Edward A. Firestone
Attorney at Law
775 Guinda St.
Palo Alto, CA 94301
Tel. No. (650) 327-0277
Cell No. (650) 269-4561

Subject: Tentative Order – Initial Site Cleanup Requirements for
1643 Contra Costa Boulevard Pleasant Hill, CA (“Site 1”)
Regional Board File No. 07S0132 (KEB)

Tentative Order – Initial Site Cleanup Requirements for
1705 Contra Costa Boulevard Pleasant Hill, CA (“Site 2”)
Regional Board File No. 07S0204 (KEB)

PCE in Soil Vapor and Groundwater Near Manhole M46 is Consistent with a Sewer Leak

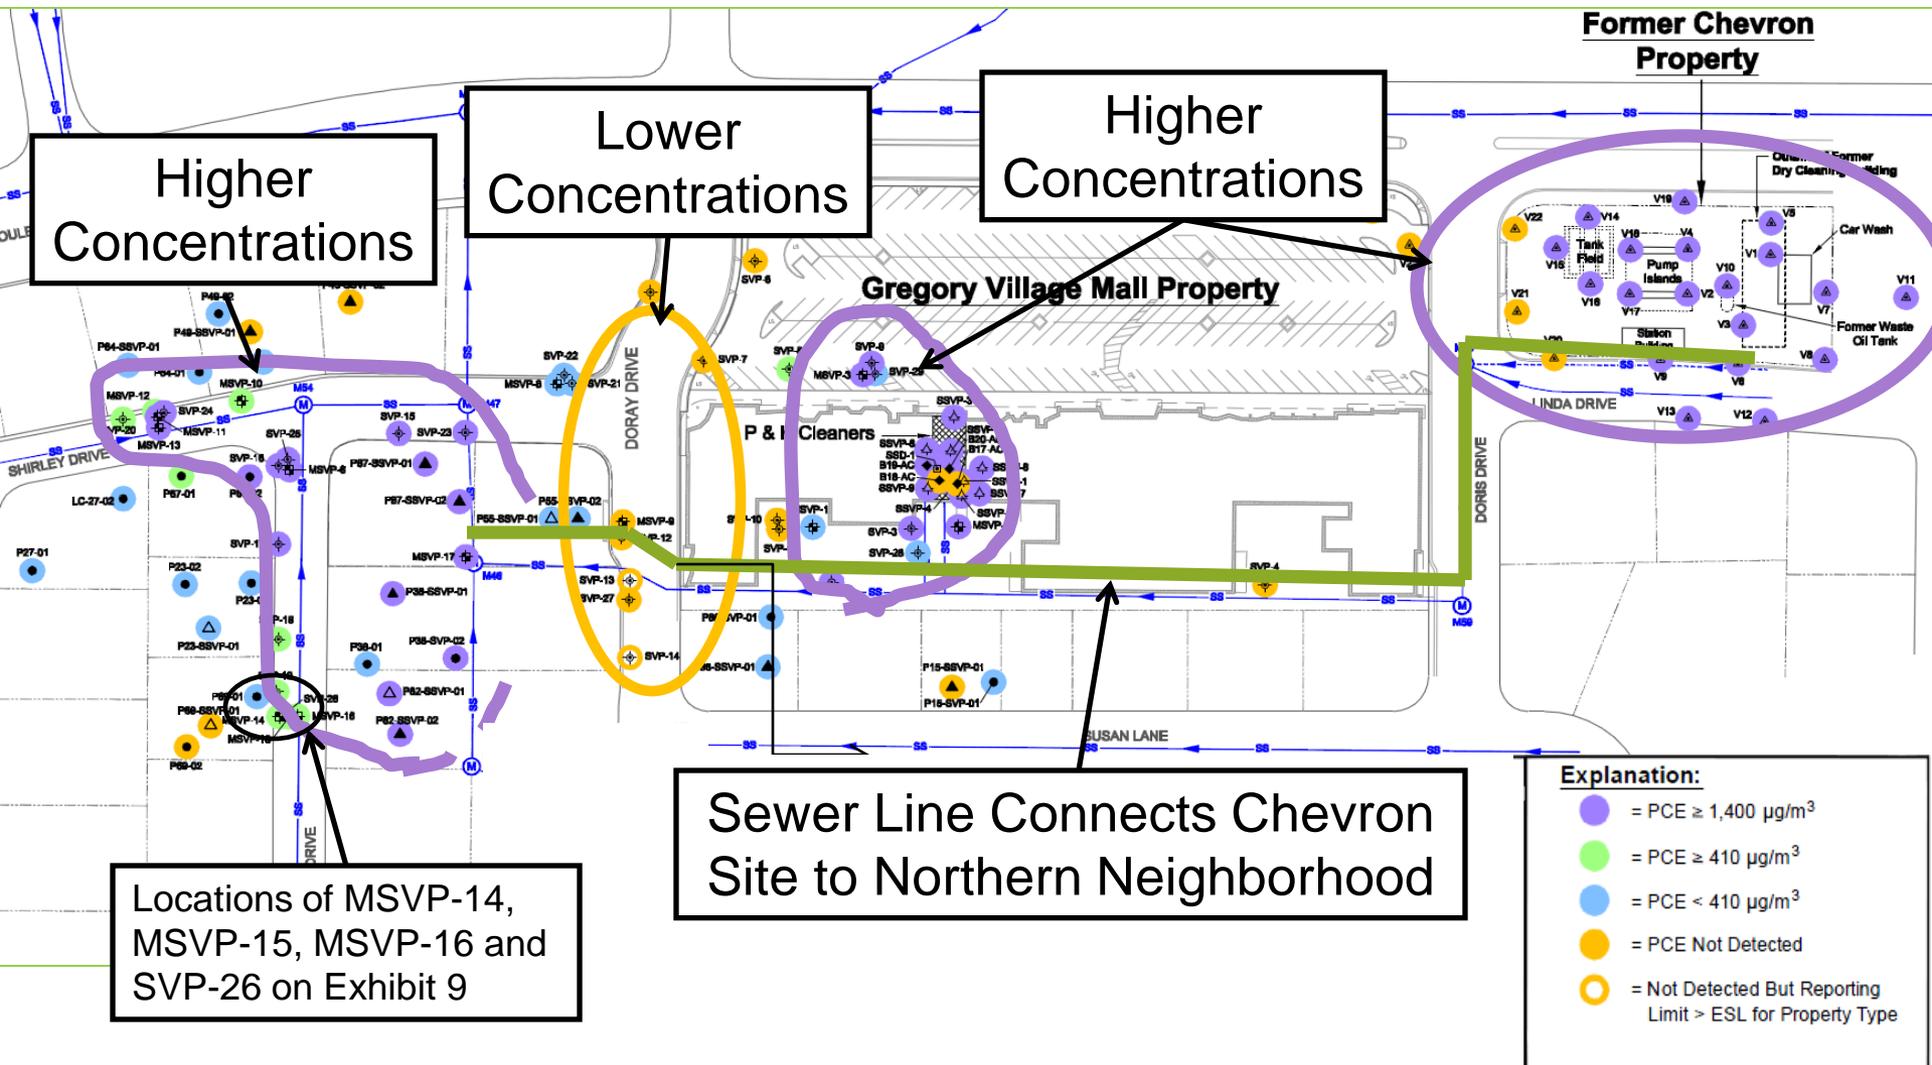
Sewer line and bottom of manhole M46 are at or below the water table

Separate Areas of High PCE Concentrations in Soil Vapor Indicate Separate Releases

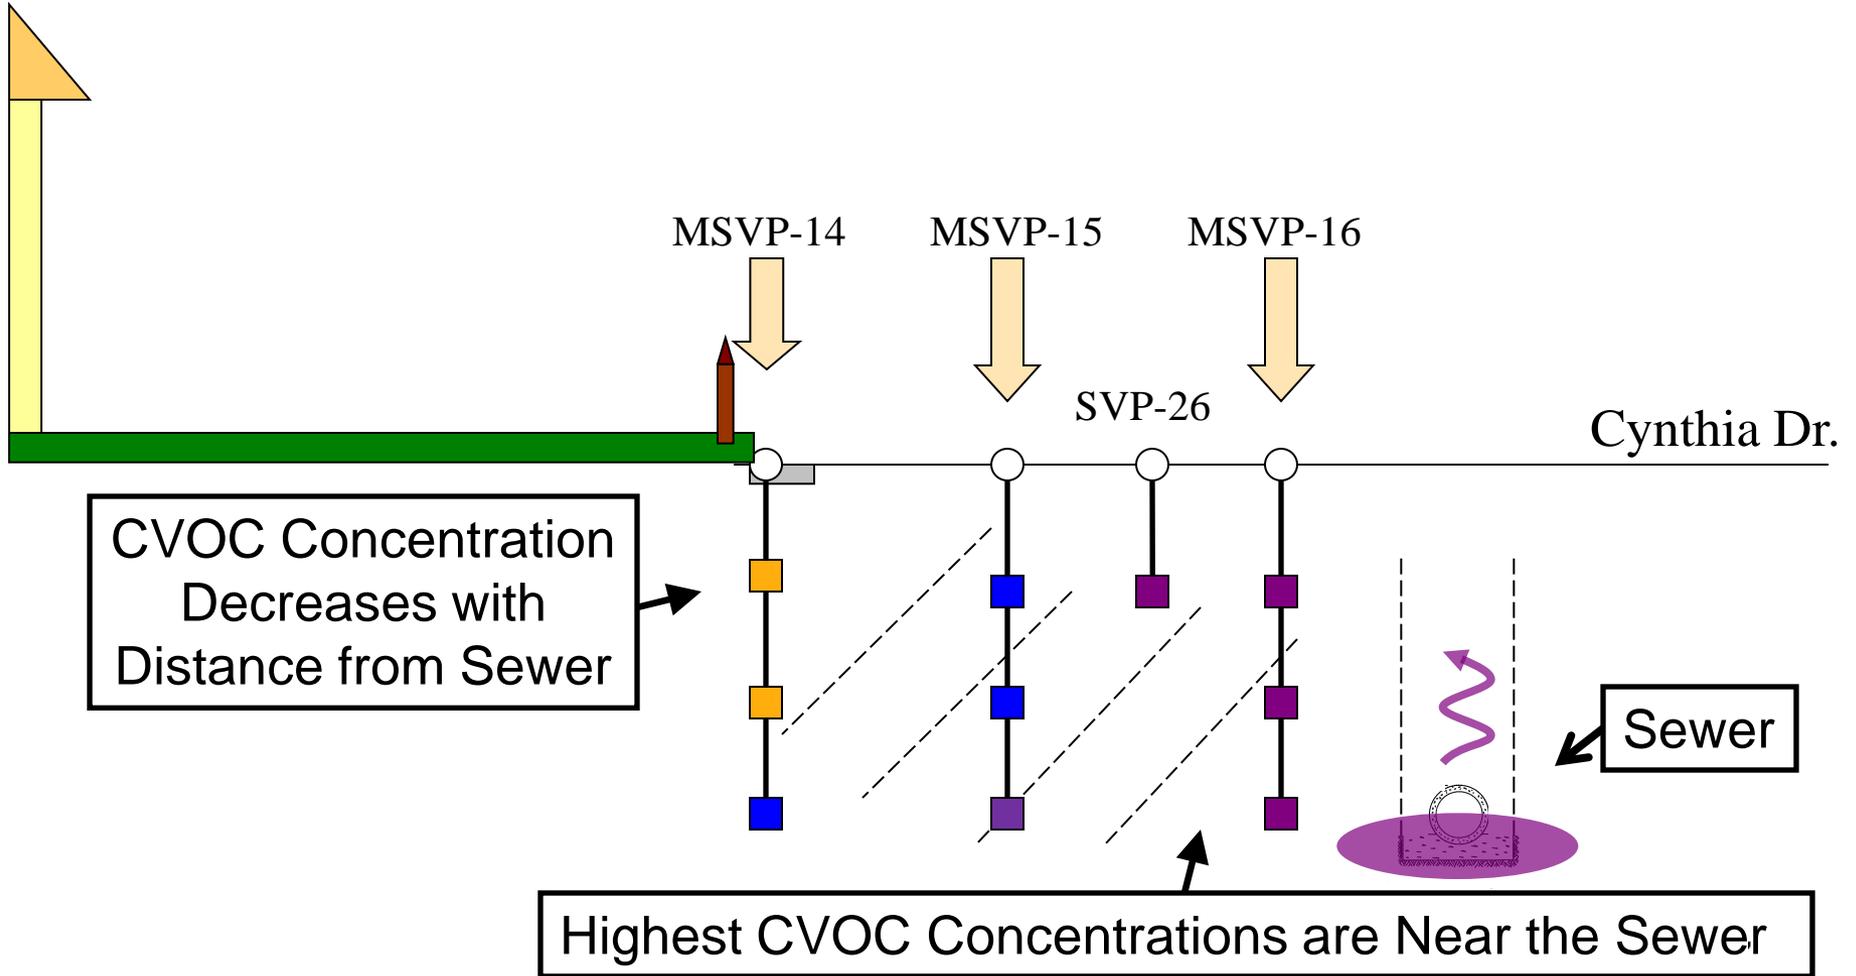
CVOC Concentrations In Soil Vapor are Highest Near the Sewer

PCE in Groundwater in Linda Drive Cross-Gradient from Chevron Site Indicative of a Sewer Leak

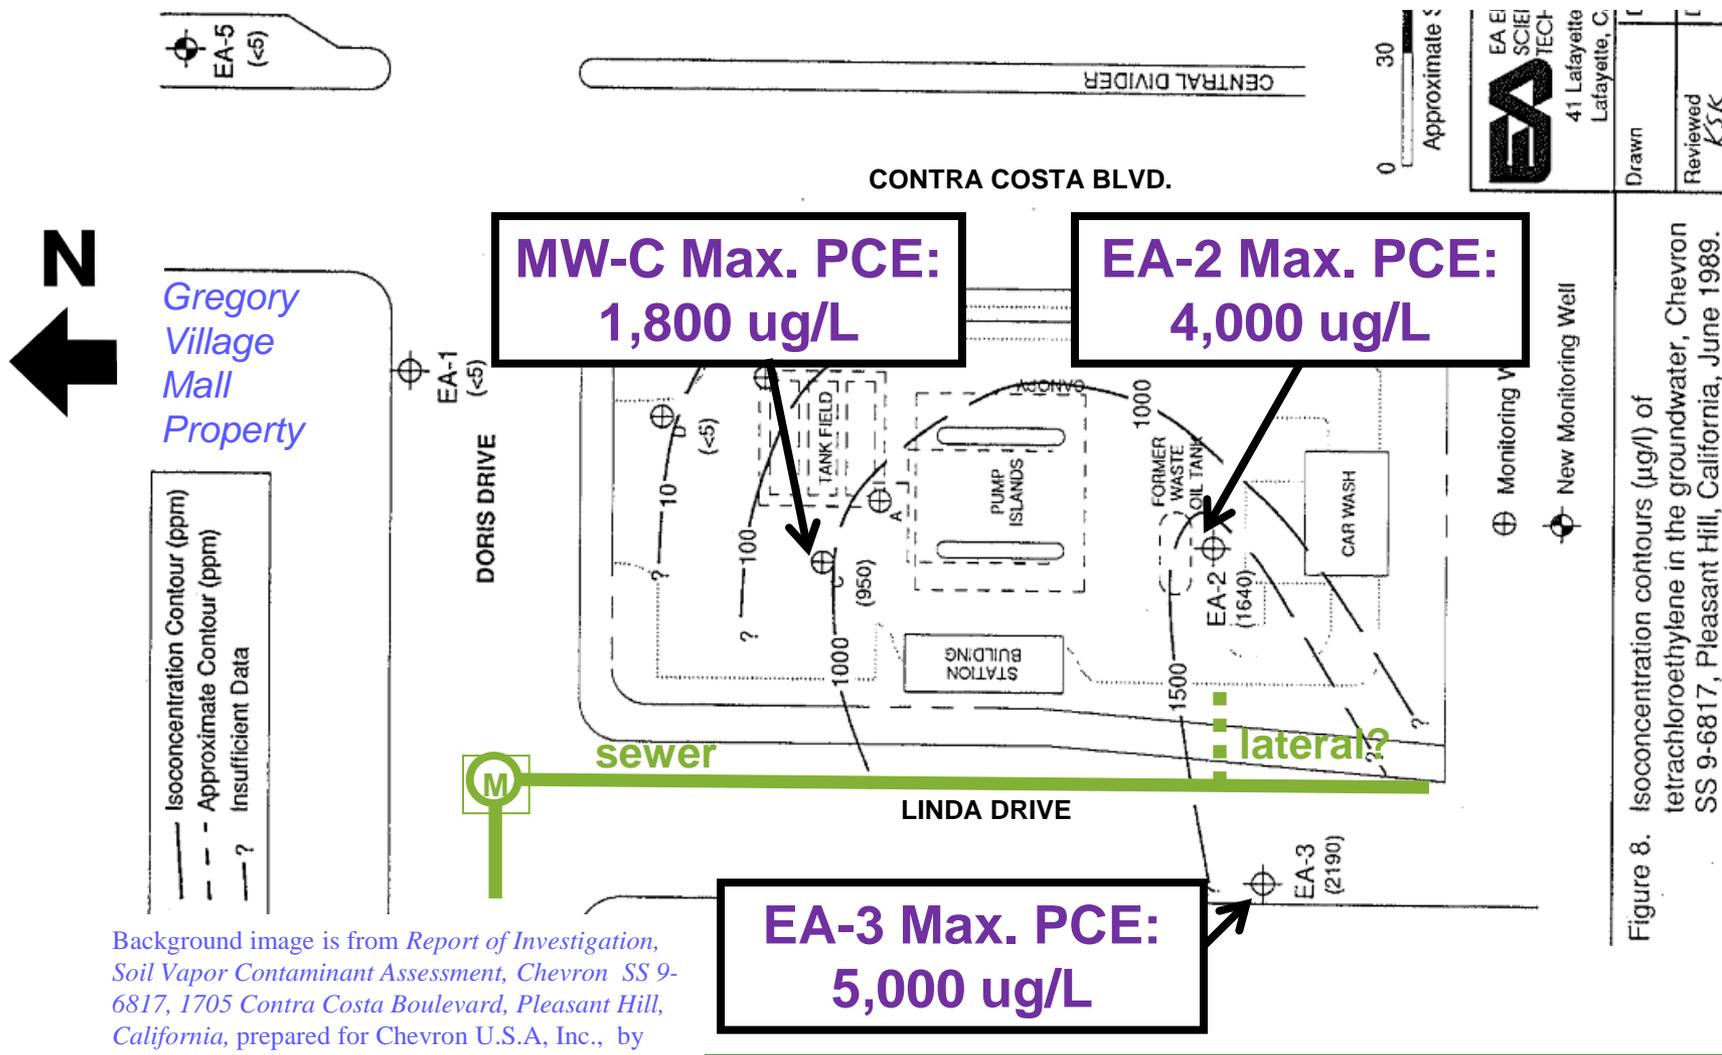
- v) CVOC Release from Sewers in Linda Drive (page 14, Section VI.1, third bullet): A CCCSD record from 1977 describes the sanitary sewer in Linda Drive as in “very poor shape has lots of cracks” (Exhibit 5 (see Exhibit 23 to that letter)). The dry cleaner and Chevron, both at Site 2, used this sewer line to discharge their waste. The Chevron Site is a site known to have high concentrations of CVOCs in soil, soil vapor, and groundwater due to releases from dry cleaner and auto repair operations, as well as elevated concentrations of PCE and TCE on the far western side of Linda Drive as early as 1988. Groundwater at former monitoring well EA-3 located on the western side of Linda Drive near the sewer, and cross gradient from Site 2, was found to have the highest PCE concentration (5,000 ug/L) of all groundwater samples collected for the early investigations of the Chevron Site (Exhibit 10). The proximity of location EA-3 to the sewer and on the opposite side of the street is evidence that that the sewer leaked waste containing CVOCs. The potential for releases for a sewer line described as having many cracks appears high, and such releases should be investigated by CCCSD and the parties responsible for the Chevron Site. The Staff Report notes the need for investigation of CVOCs in and downgradient of Linda Drive, but the Order for Site 2 fails to specify any such required investigations nor is there any current requirement for CCCSD to do so.

same time, monitoring well EA-3 located in Linda Drive was sampled and had PCE and TCE in groundwater at 5,000 ug/L and 750 ug/L, respectively.
